INA Service Info

Optimized tensioner and deflection pulley bearings

New sealing concept

Figure 2: Deflection pulley with new sealing concept (without cap)

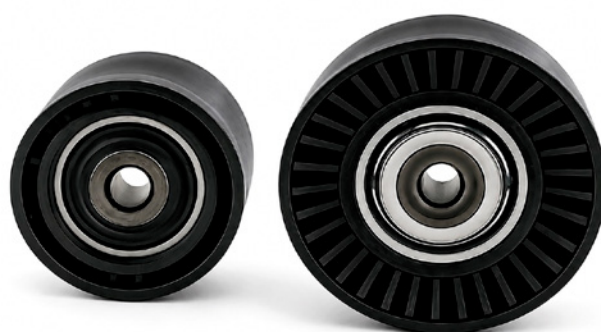
Due to the continuous development of our products, the bearings of many tensioner and deflection pulleys are now equipped with a new sealing concept. This innovative sealing system has the advantage of significantly higher resistance to harmful external influences including dust, dirt and moisture.

A decisive difference to the previous tensioner and deflection pulleys is that the cover cap (Figure 1) is no longer required. Due to the optimization, it is no longer included as a package insert in the new versions (Figure 2).

In the transition phase, mixed stock in the warehouse may result in tensioner and deflection pulleys being supplied with a cover cap as well as without a cover cap. Both versions meet the technical specifications and can be installed without any problems.

It is not possible and not necessary to convert cover caps that have already been used in tensioner and deflection pulleys using the new sealing concept!
